Work Order ID 87835

Item Name: Replacement Skidtube

| DRAWING NO. D2580 | TITLE 205 SKIDTUBE ASSEMBLY | REV. E | DART AEROSPACE LTD ENGINEERING ORDER | D.E.O. NO. D2580-E-1 | SHEET NO. SHEET 1 OF 1 | SCALE NTS |

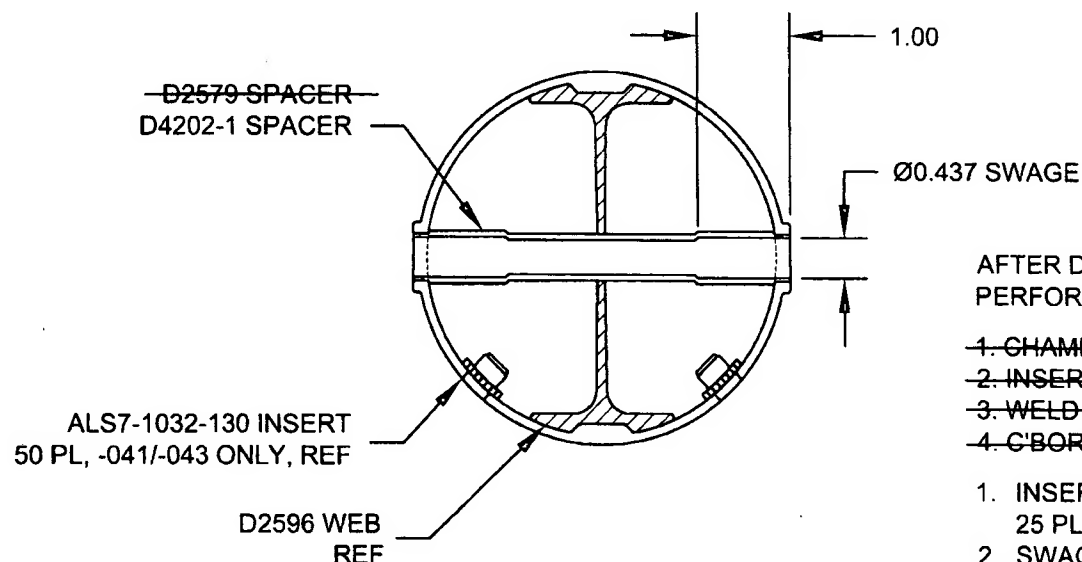
CHANGE ALL C'BORED WELDED CROSSBOLT SPACERS TO SWAGED SPACERS

SECTION B-B, SECTION F-F, & SECTION I-I ARE AMENDED AS FOLLOWS
FOR ALL HOLES THAT WERE ORIGINALLY C'BORED:

*** FOR -045 SKIDTUBE ONLY:**

WELD 4X D2579 SPACERS PER DWG
IN LOCATIONS MARKED "NO C'BORE".
REF SHEET 4 OF DWG.
